Lee Nuclear Station Units 1 and 2

Evaluation of 2012 Field Investigation Results for Plant Relocation

FIGURE 20

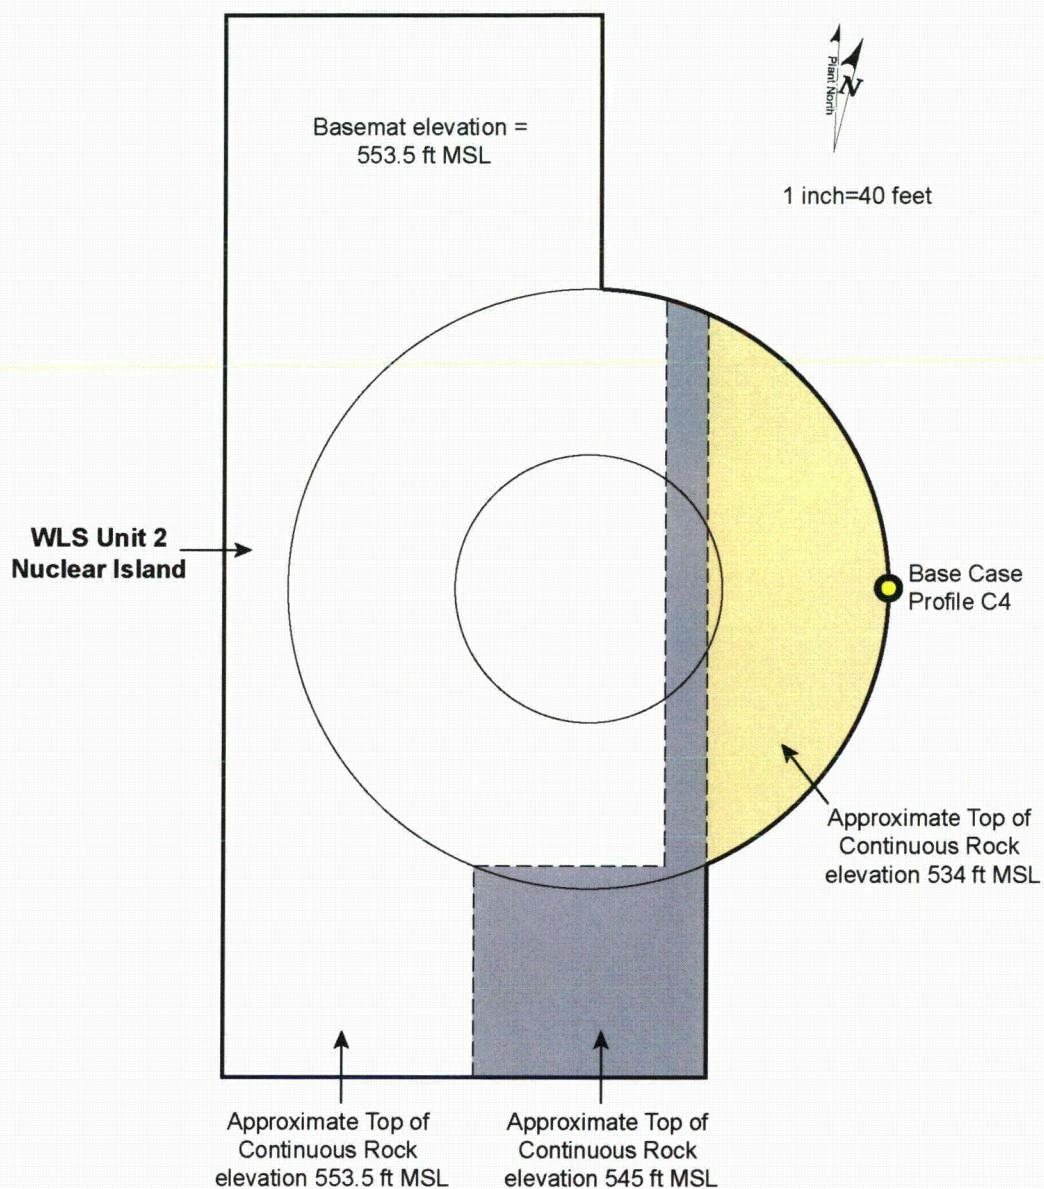
As illustrated in Figure 20, the conditions associated with FIRS A5 are only applicable to a small localized portion of the Unit 1 footprint, while FIRS A1 is applicable to the remainder. Since the nuclear island basemat will respond as a unit, the actual input to the nuclear island will be much closer to FIRS A1, and the contribution of FIRS A5 will not adversely impact the overall response of Unit 1. Similarly, FIRS C4 was developed as a sensitivity analysis of the potential effects of localized fill concrete beneath the eastern extents of Unit 2. The potential effects of

2012. This subsection will include a discussion regarding the existing Cherokee Nuclear Station concrete foundation that has several local pits (referred to as pump rooms) that were to serve various purposes (Figure 20). These local pits were typically to be provided with horizontal and vertical waterproofing membranes. In pits having the horizontal and vertical waterproofing membranes, these features will be removed down to the top of the fill concrete layer resting on the continuous rock and outward to the surrounding rock and replaced with new fill concrete.

FIGURE 21

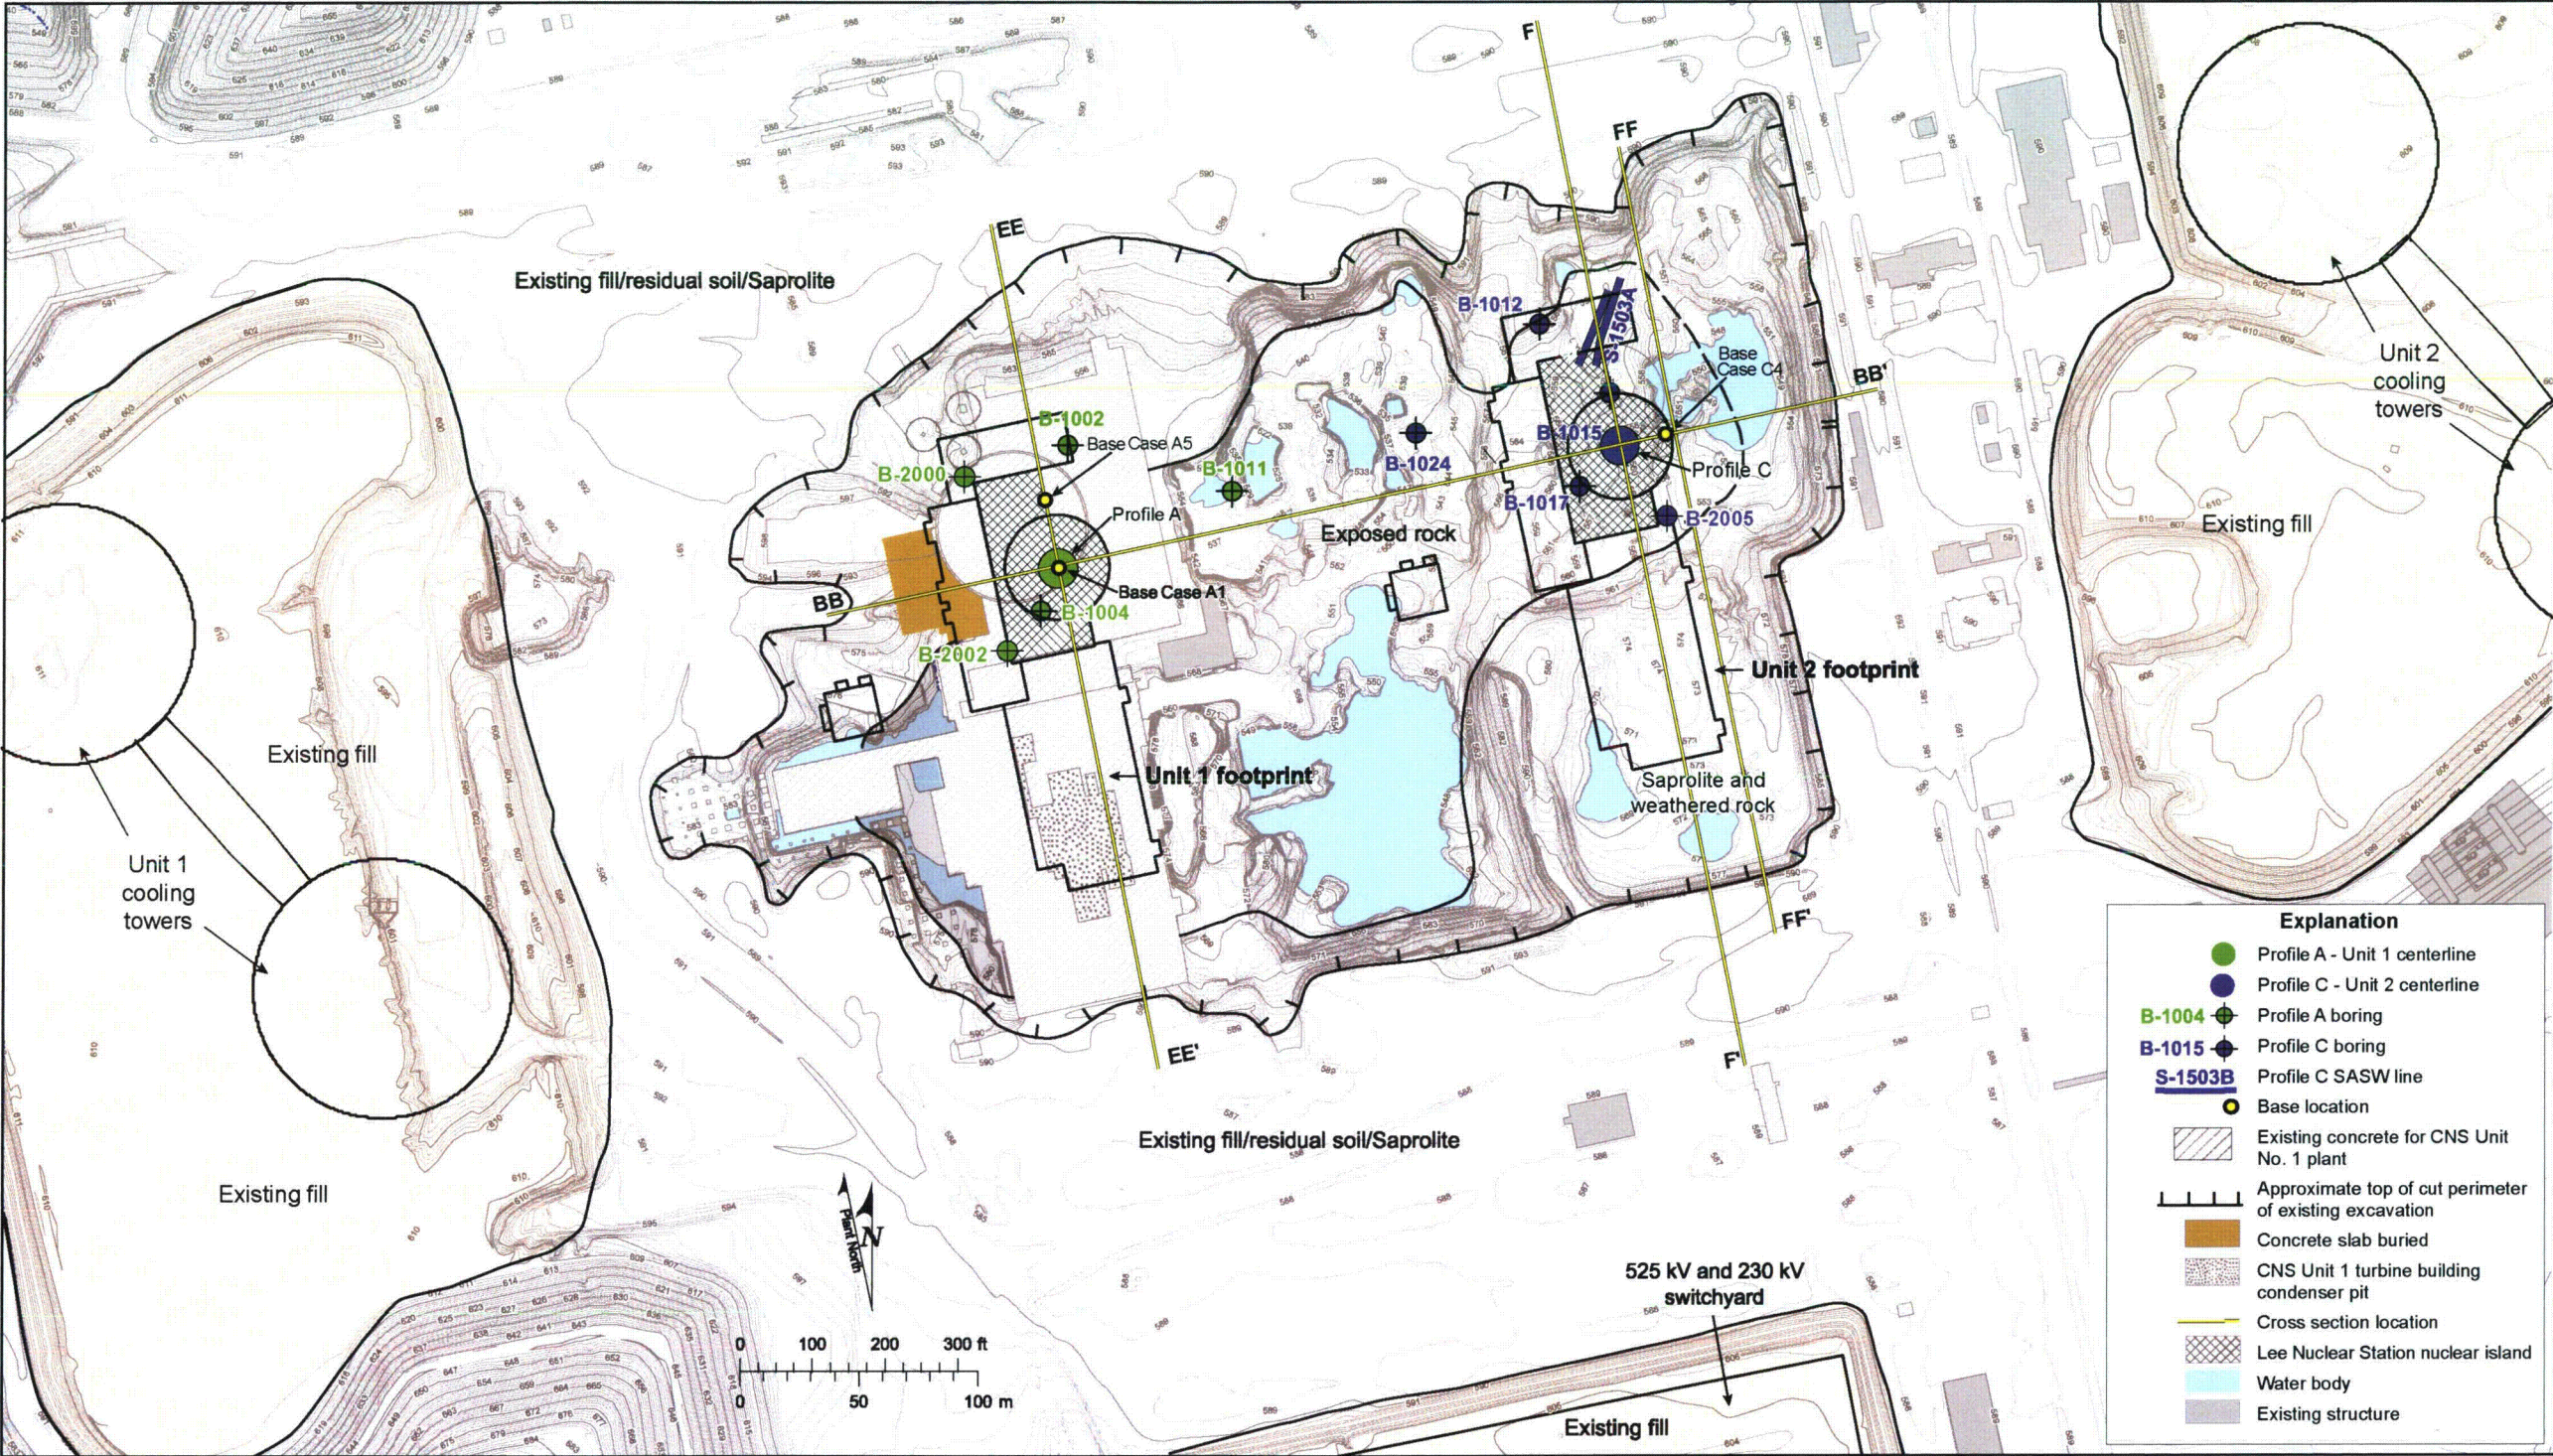
FSAR Subsection 2.5.4.5.2.2 – Unit 2 Excavation Conditions, will be revised to note that the eastern edge of the relocated nuclear island will require about 20 ft. of fill concrete between the bottom of the nuclear island and the top of continuous rock (Figure 21). The central and western portions of the relocated WLS Unit 2 nuclear island will require only minimal thicknesses of fill concrete.

This subsection will be revised to reflect the maximum thickness of fill concrete is about 16 to 20 feet beneath the east portion of the nuclear island, but generally will be less than about 1 to 2 feet as depicted in Figures 16 and 21 (new FSAR Figures 2.5.4-264 and 2.5.4-267). This relatively small area of concrete fill required to build up the eastern edge of the Unit 2 nuclear island basemat will not result in localized adverse conditions due to the relatively small difference in shear wave velocity of fill concrete (7,500 ft/sec) and rock (8391 to 8983 ft/sec) in this area. The fill concrete conditions described for the Lee Nuclear Station Unit 2 nuclear island eastern portion have no practical significance on differential shear wave velocity, site amplification or foundation performance.

- For relocated Unit 2, the eastern edge of the relocated nuclear island foundation will be supported on about 20 ft. of fill concrete between the bottom of the nuclear island and the top of continuous rock (Figure 21). This relatively small localized area of concrete fill underlying the eastern edge of the relocated Unit 2 nuclear island will not result in localized amplification / deamplification effects due to the relatively small difference in the average shear wave velocities for fill concrete (7,500 ft./sec.) and surface rock (8,391 ft./sec. to about 8,983 ft./sec.) in this area (FSAR Figure 2.5.4-250). The addition

FIGURE 29

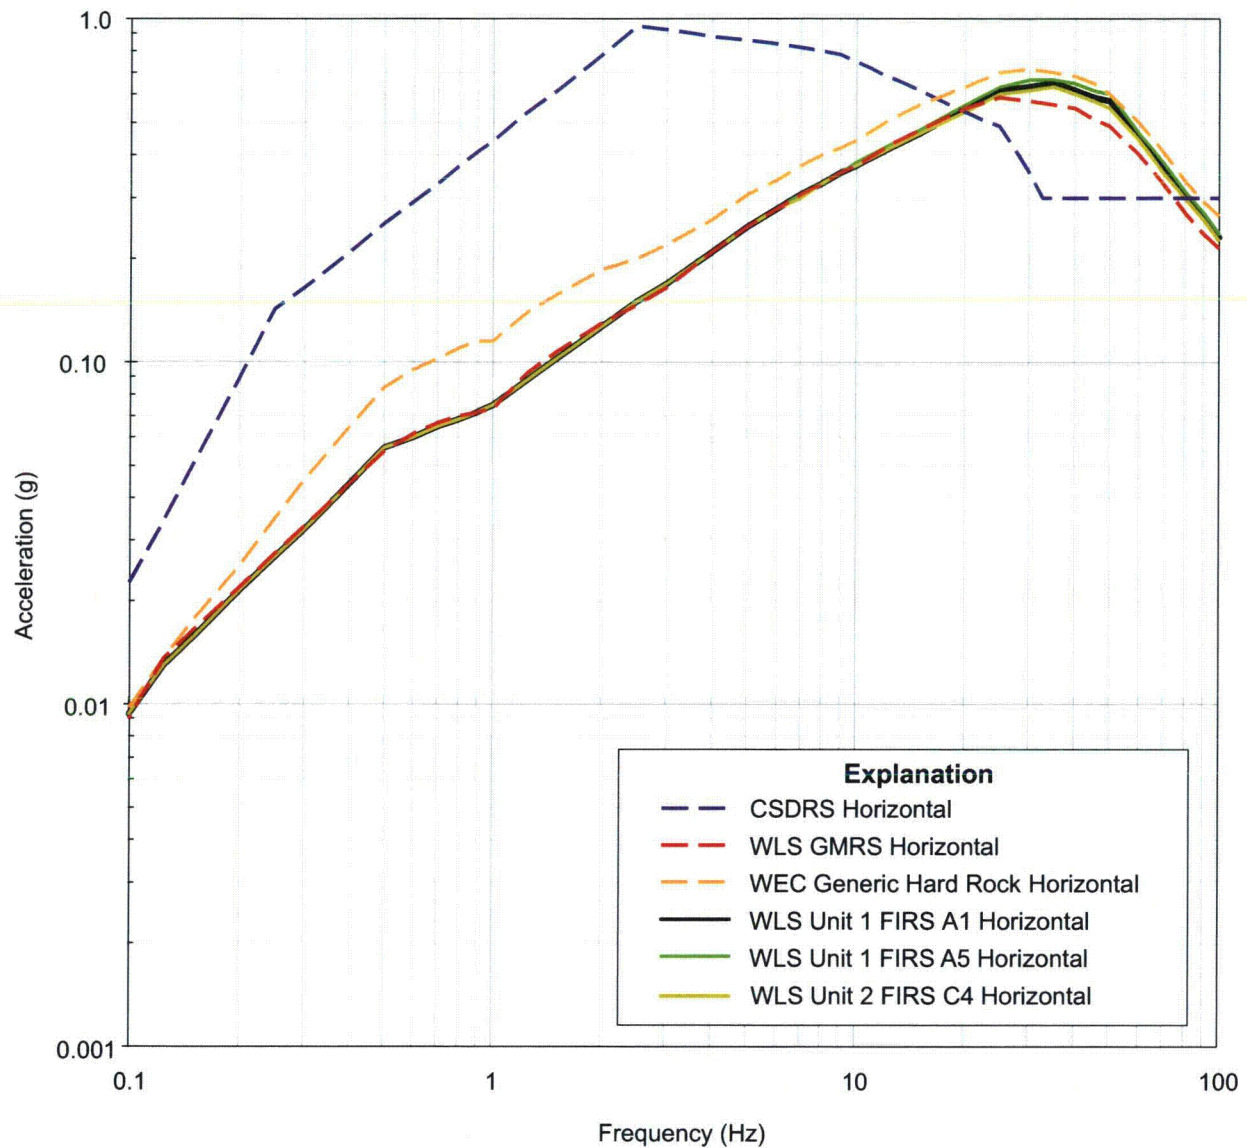
Minor revisions to the stability of slopes subsection presented in FSAR Revision 6 are necessary to accommodate the relocated plant structures. These revisions will be made in a future revision of the FSAR. Figure 29 (Revised FSAR Figure 2.5.5-201) shows the location of permanent slopes to the relocated structures. There are no changes to conclusions presented in the WLS FSAR.

FIGURE 30

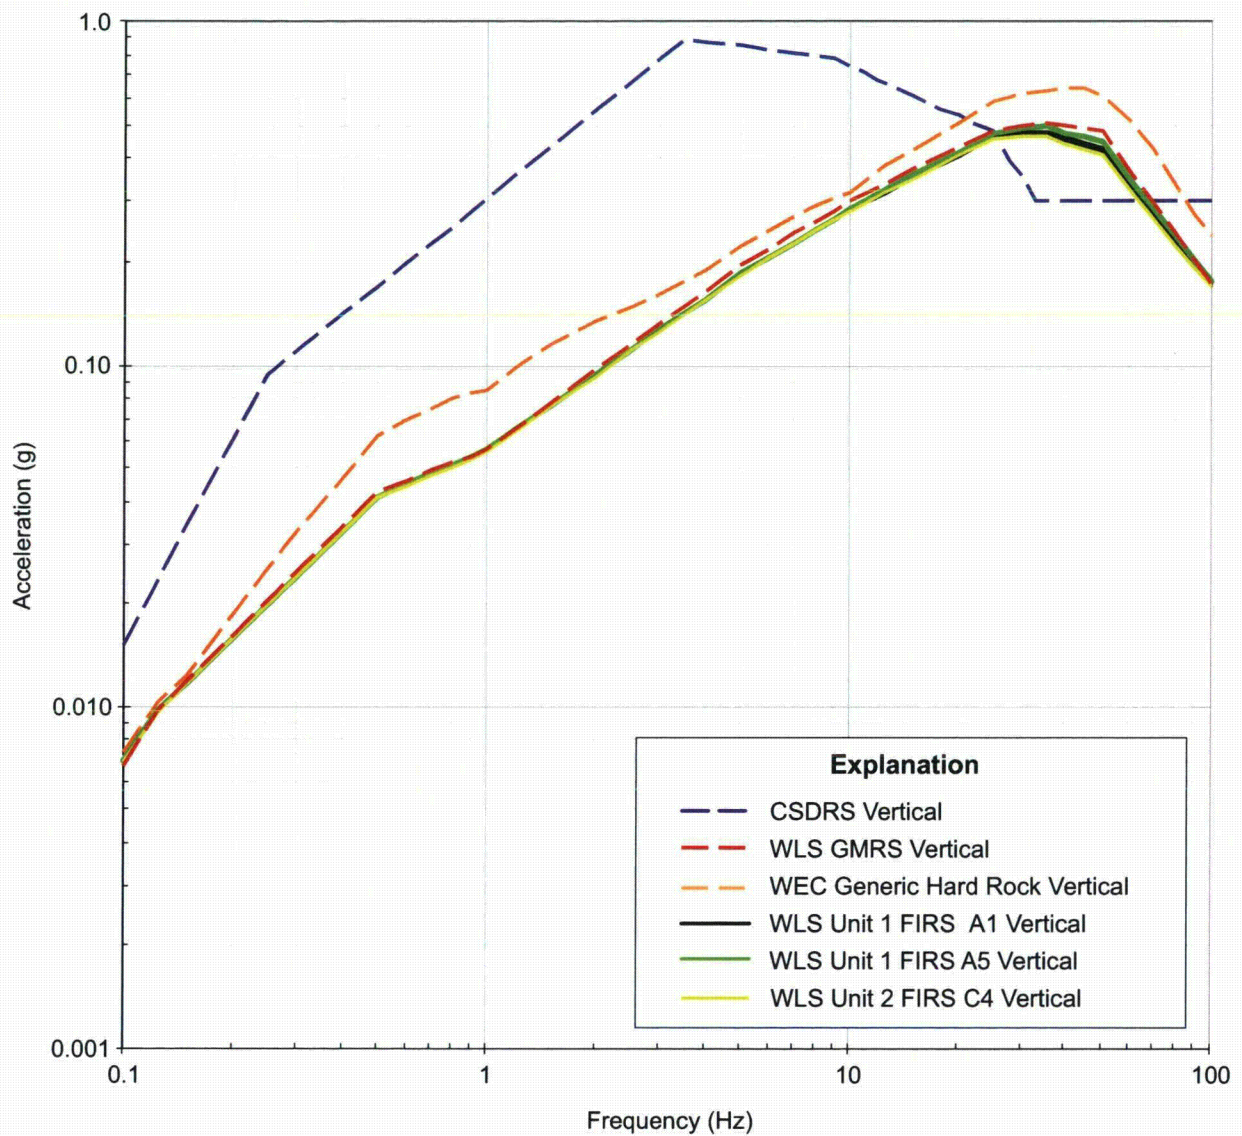
As shown on Figure 30, the horizontal GMRS and Unit 1 FIRS (revised FSAR Figure 3.7.1-201) exceed the horizontal CSDRS at frequencies of about 20 to 75 hertz and 20 to 85 hertz, respectively. PGA at 100 hertz of the GMRS and Unit 1 FIRS is 0.21 g and 0.23 g, respectively. As shown on Figure 31, the vertical GMRS and Unit 1 FIRS (revised FSAR Figure 3.7.1-202) exceed the vertical CSDRS at frequencies between about 25 to 70 hertz. There is no change to the conclusion expressed in the FSAR Revision 6 that the WLS site provides uniform hard-rock support for the nuclear island, and the site characteristic GMRS and Unit 1 FIRS are less than the horizontal and vertical WEC generic hard rock spectrum at all frequencies. The site complies explicitly with the AP1000 DCD and no site-specific analysis is required.
